Access Compliance Report Public Rights-of-Way (Curb Ramps)

Main Street: O_NEILL_DR Cross Street: NARROW_CANYON_RD Location: NW

ADA ID: RPRK211103151232 Ramp Type: Type 4 - Parallel Initial Pass/Fail: Fail Overall Compliance: No Severity Score: 2

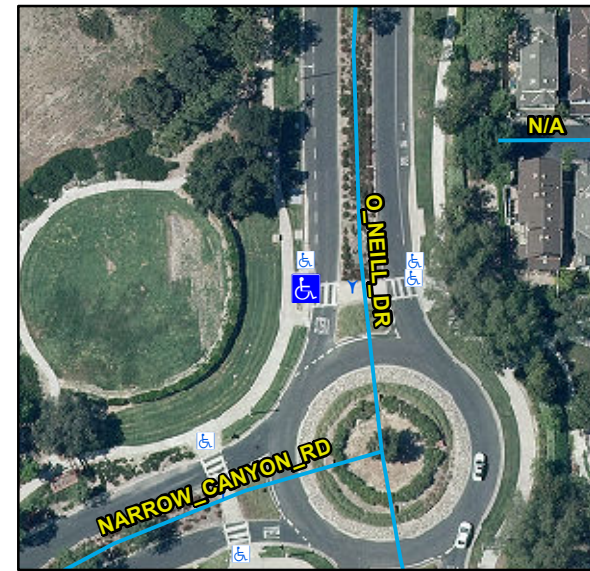
Compliance	Description	Data	Compliance	Description	Data
N/A	Ramp Length LT (in)	84	N/A	Ramp Length RT (in)	-9999
Yes	Ramp Width LT (in)	50	N/A	Ramp Width RT (in)	-9999
Yes	Ramp Run Slope LT (%)	5.1	N/A	Ramp Run Slope RT (%)	-9999
No	Ramp Cross Slope LT (%)	4.2	N/A	Ramp Cross Slope RT (%)	-9999
N/A	Landing Present	N/A	N/A	DWS Provided	N/A
N/A	Landing Length (in)	N/A	N/A	DWS Contrast	N/A
N/A	Landing Width (in)	N/A	N/A	DWS Length (in)	N/A
N/A	Landing Run Slope (%)	N/A	N/A	DWS Full Width	N/A
N/A	Landing Cross Slope (%)	N/A		DWS Offset Type	N/A
N/A	Landing Movement Obstructed?	N/A	N/A	DWS Offset Left (in)	N/A
	Landing Movement Type	N/A	N/A	DWS Offset Right (in)	N/A
N/A	Landing Shared	N/A			
N/A	Clear Space	N/A			
N/A	Clear Space To Crosswalk (in)	N/A			
N/A	Marked Crosswalk 1	Yes	N/A	Marked Crosswalk 2	N/A
	Crossing 1 Direction	E		Crossing 2 Direction	N/A
N/A	Marked Crosswalk 1 Width (in)	144		Marked Crosswalk 2 Width (in)	N/A

Remove & Replace Entire Ramp.
